Proposal for a new 02 Series of Amendments to UN Regulation No. 160 (Event Data Recorder)

The text reproduced below was prepared by the expert from the International Organization of Motor Vehicle Manufacturers (OICA) to introduce the requirements of new verification procedures with transitional provisions to allow for necessary preparation time. The text is based on chapter 6 of the proposal by the IWG on EDR/DSSAD (see documents ECE/TRANS/WP.29/GRSG/2023/11 and ECE/TRANS/WP.29/GRSG/2023/15) and is marked in blue bold for new and blue strikethrough for deleted characters.

Corridor +/- 10 Per Cent of the Full-Scale Range of the Accelerometer

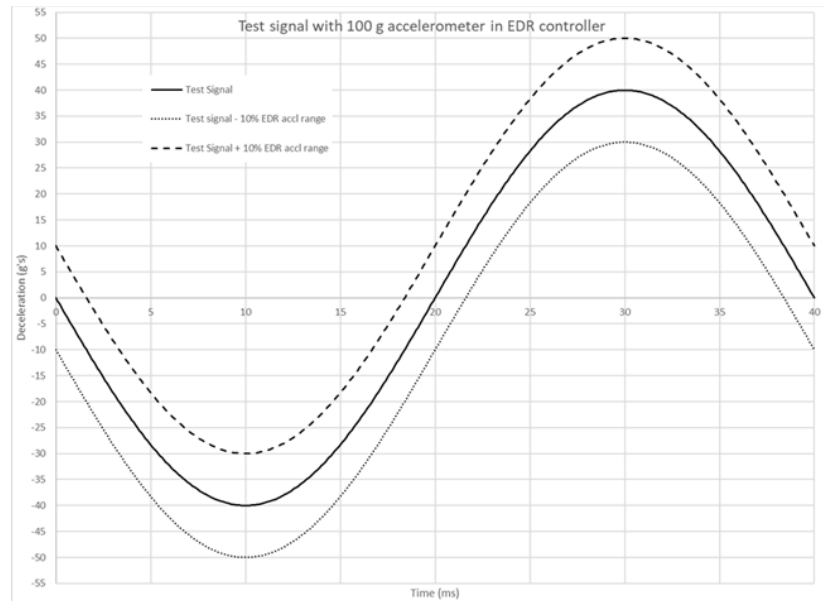
6.1.5. The EDR recorded acceleration trace shall be fully contained in a corridor that is +/- 10 per cent of the full-scale range of the accelerometer used by the controller containing the EDR applied to the component test fixture's filtered acceleration trace. The comparison of acceleration sensor traces shall only be made on the axis the component test was conducted.

For example, if the accelerometer in the controller containing the EDR function has a +/- 100 g range, then +/- 10 g would be applied to the component test fixture's filtered acceleration trace. The EDR recorded acceleration trace shall be fully contained within that corridor (see the Figure).
